SUBJECT: AMENDMENT NO. 140 TO FACILITY OPERATING LICENSE NO. DPR-43 -
 KEWAUNEE NUCLEAR POWER PLANT (TAC NO. MA1499)

AMENDMENT TO FACILITY OPERATING LICENSE

Amendment No. 140
License No. DPR-43

SAFETY EVALUATION BY THE OFFICE OF NUCLEAR REACTOR REGULATION

FIGURE TS 3.1-3

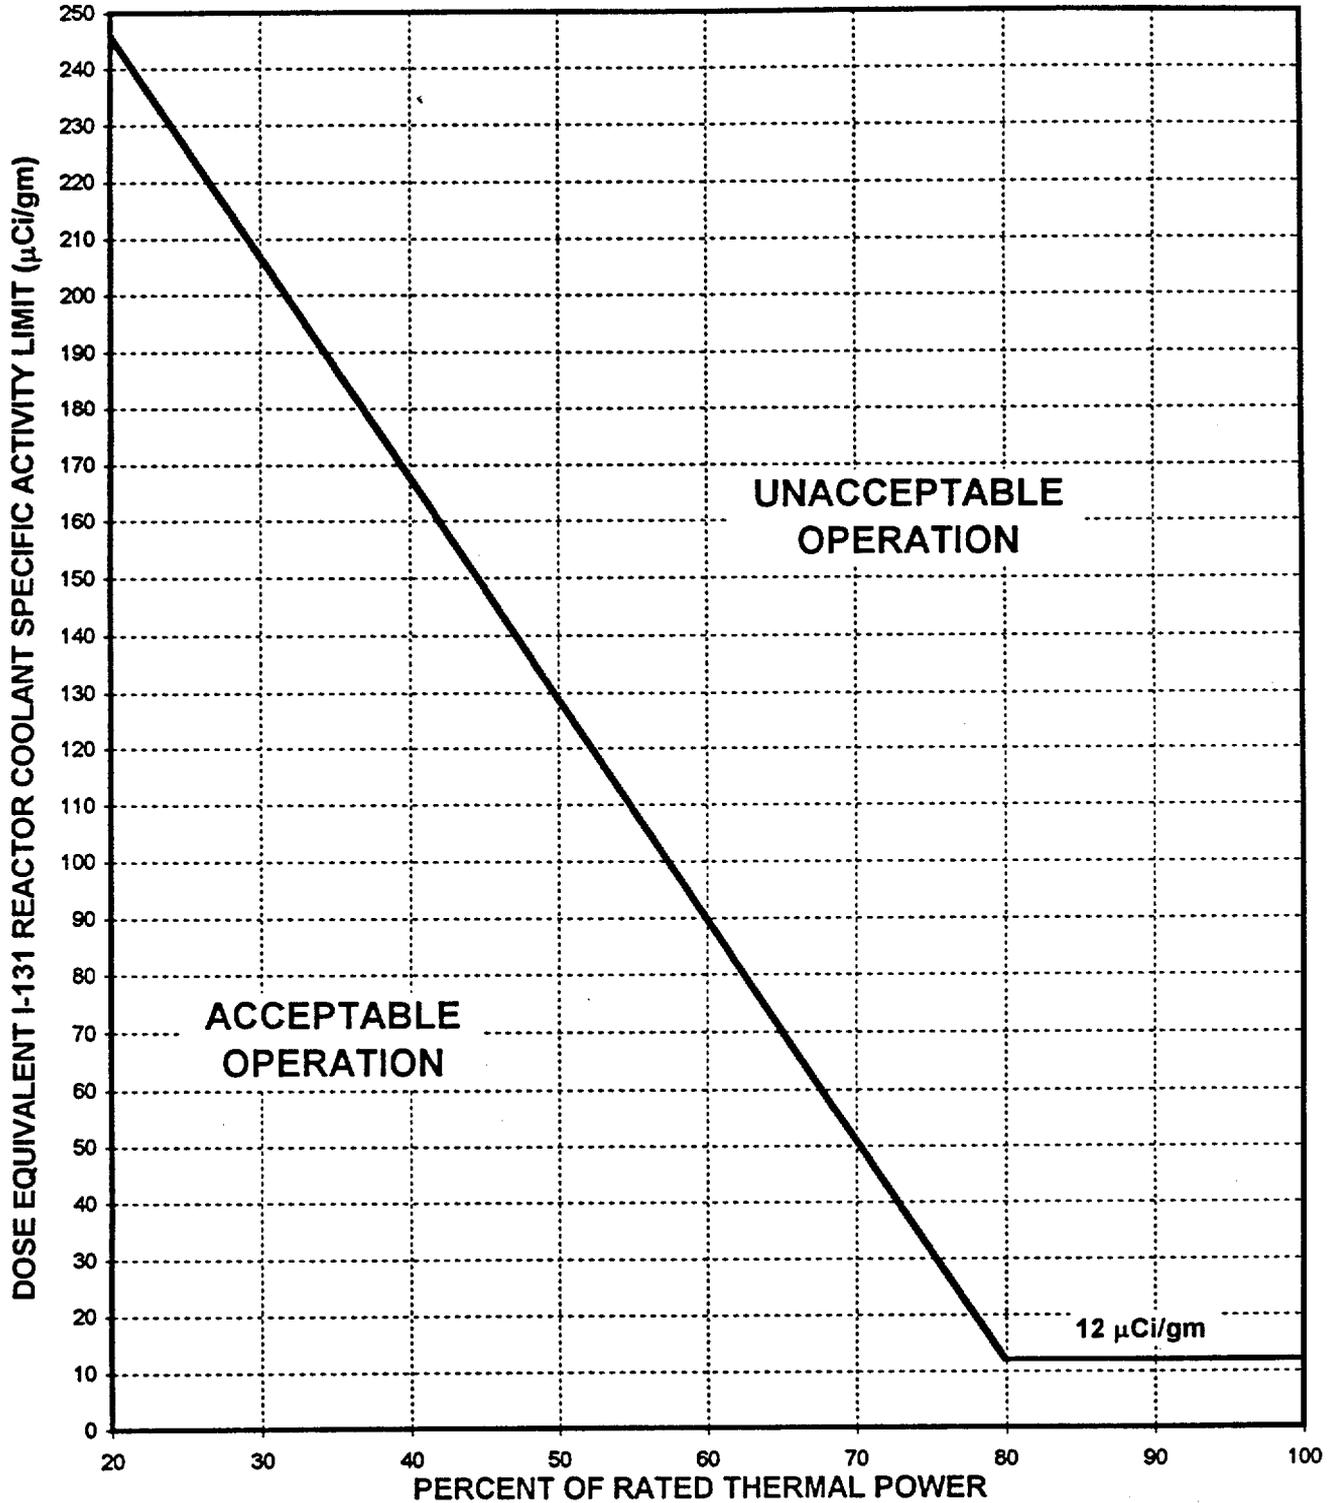
A. With the specific activity of the reactor coolant $> 0.20 \mu\text{Ci}/\text{gram}$ DOSE EQUIVALENT I-131 for more than 48 hours during one continuous time interval, or exceeding the limit shown on Figure TS 3.1-3, be in at least INTERMEDIATE SHUTDOWN with an average coolant temperature of $< 500^\circ\text{F}$ within 6 hours.

The action statement permitting power operation to continue for limited time periods with reactor coolant specific activity $> 0.20 \mu\text{Ci/gram DOSE EQUIVALENT I-131}$, but within the allowable limit shown in Figure TS 3.1-3, accommodates the possible iodine spiking phenomenon which may occur following changes in thermal power.
